2021-2026 Victorian Electricity Distribution Price Reset

Summary of engagement with Victorian
Community Organisations

May 2020

**Brotherhood
of St Laurence**

Figure 10 Solar constraints by zone substation (percentage of daylight hours)

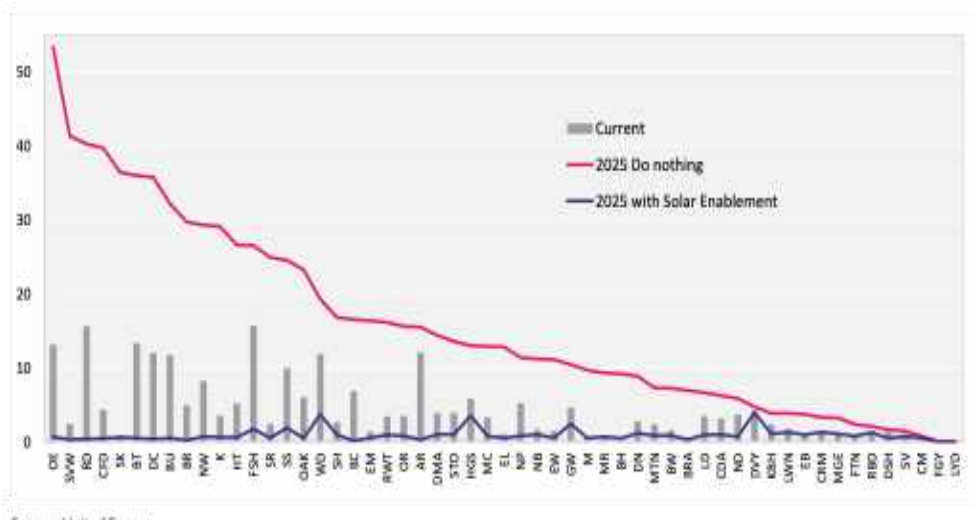
1. In point 5.2.2 of the Solar Enablement business case, you explained that the DVMS (dynamic voltage management system) would allow a greater amount of solar PV to be connected before experiencing constraints. How much does dynamic voltage control increase the PV capacity of a line? If constraints are assumed to occur at 30% penetration normally, at what penetration would they occur if voltage control was implemented (if that is a simplification – are you able to express the extent of improvement in other terms?) Do you have a sense of how the chart below would be impacted for each distributor by rolling out DVMS and dynamic controls, without the augmentation such as transformer and LV asset replacement needed to allow PV to be exported to the HV network?

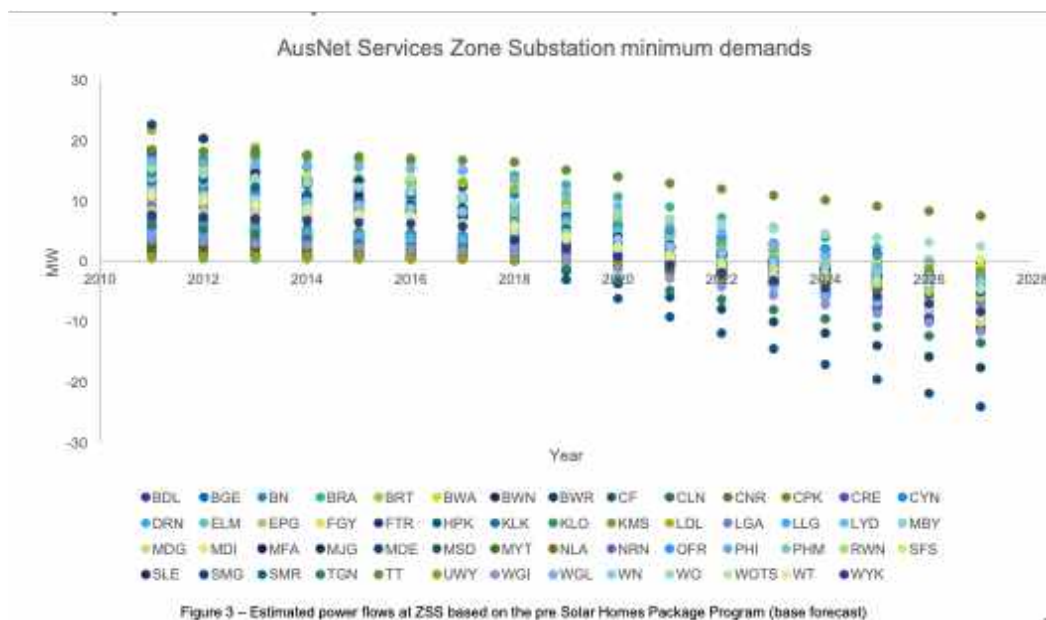
5. The chart below suggests that more than half of the ZSSs will be exporting generated load to the HV network by 2023. This develops very rapidly over the following 5 years so that almost all ZSSs will be exporting to the HV networks at minimum constraint periods.

Much of this export can be expected to occur at the same time.

Will this cause constraint on the HV network? How will this be managed?
